Improving Toshiba TPH Performance

Step Less Polish

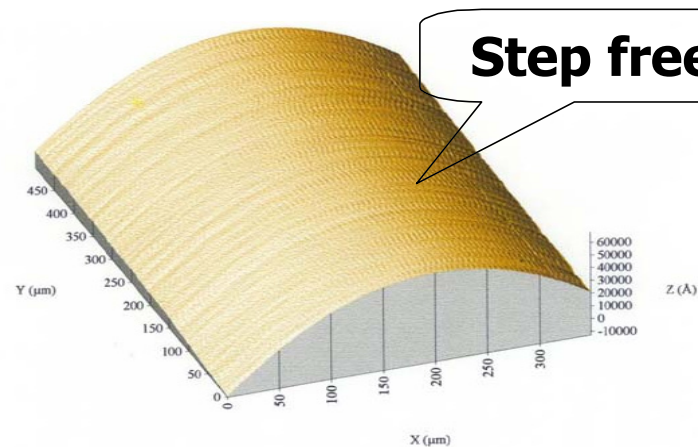
To improve heat effect, next step sample will be added “Step Less Polish” process. It is expected that medium contact will be improve.

Also Toshiba estimates step less polish would decrease friction coefficient, it will prevent to get wrinkles.

These effects are under verifying, but Toshiba believe its effect.
